ENCLOSURES:
Request for change to tech specs.....consist of Title changes within the station organization....and Changes to the Station organization chart, Fig. 6.1-1

Re: Oconee Nuclear Station
Docket Nos. 50-269, -270, -287

Section 6.1.1 of the Oconee Nuclear Station Technical Specifications, Appendix A to Facility Operating Licenses DPR-38, -47, and -55, specifies the organization of Oconee Nuclear Station. Pursuant to 10CFR50.59, it is requested that the Oconee Nuclear Station Technical Specifications be revised to show:

FIGURE 6.1-1

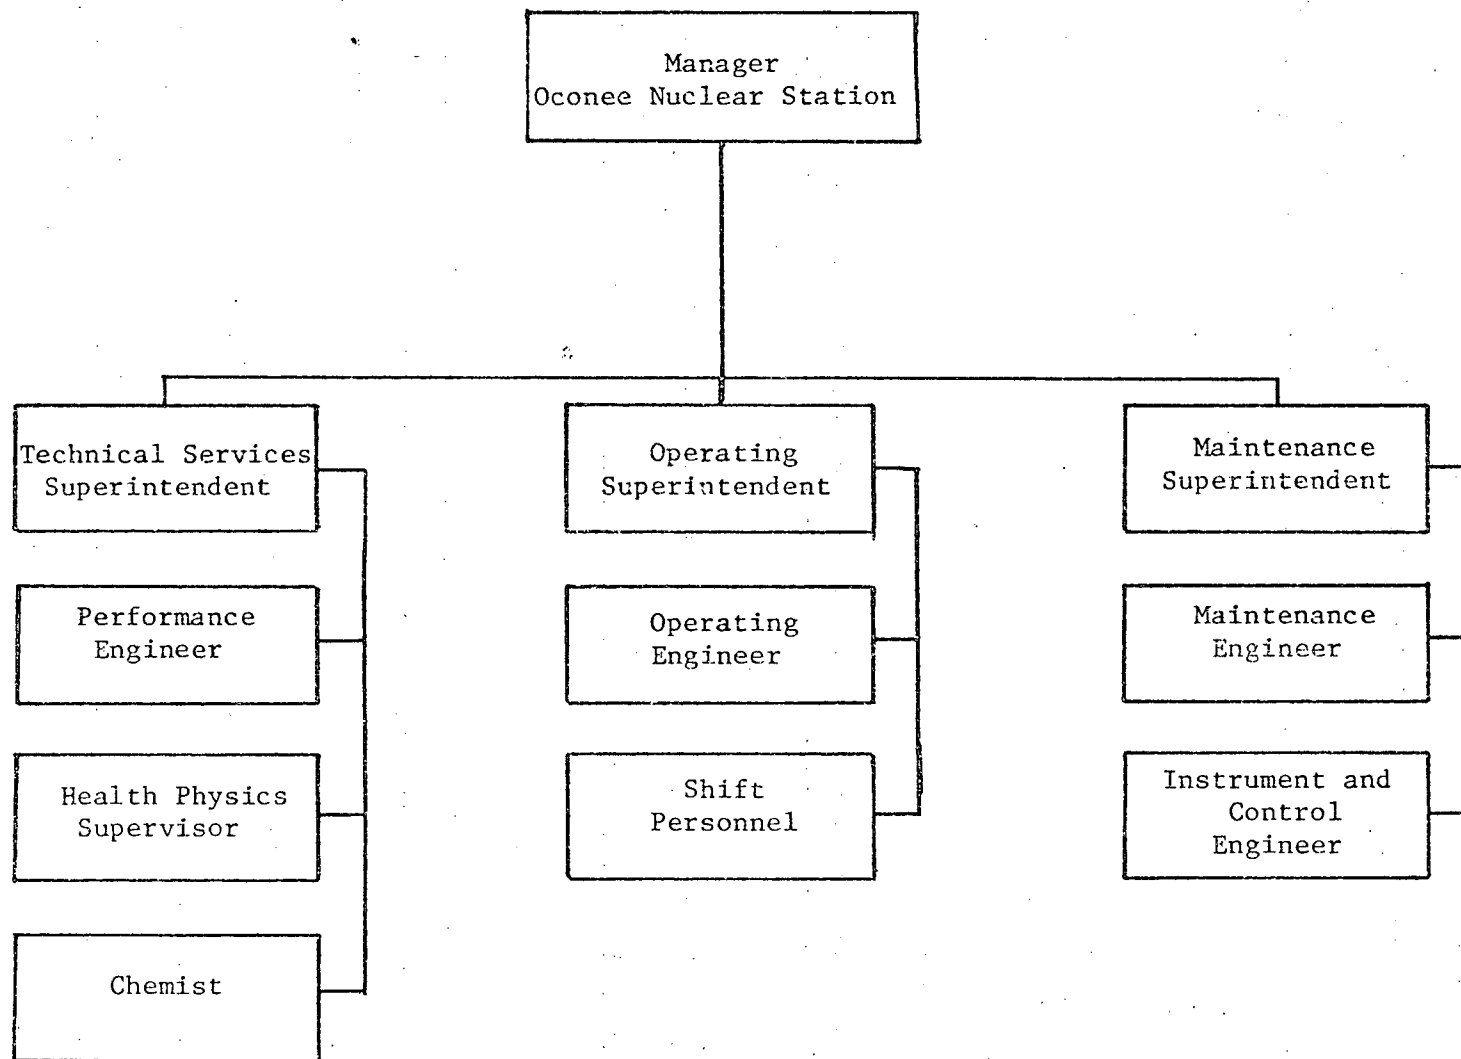
1. Title changes within the station organization such as Superintendent to Manager, Technical Support to Technical Services, etc.
2. Changes to the station organization chart, Figure 6.1-1.

6.1.1.3 The station organization for Operations, Technical Services, and Maintenance shall be functionally as shown in Figure 6.1-1. Minimum operating shift requirements are specified in Table 6.1-1.
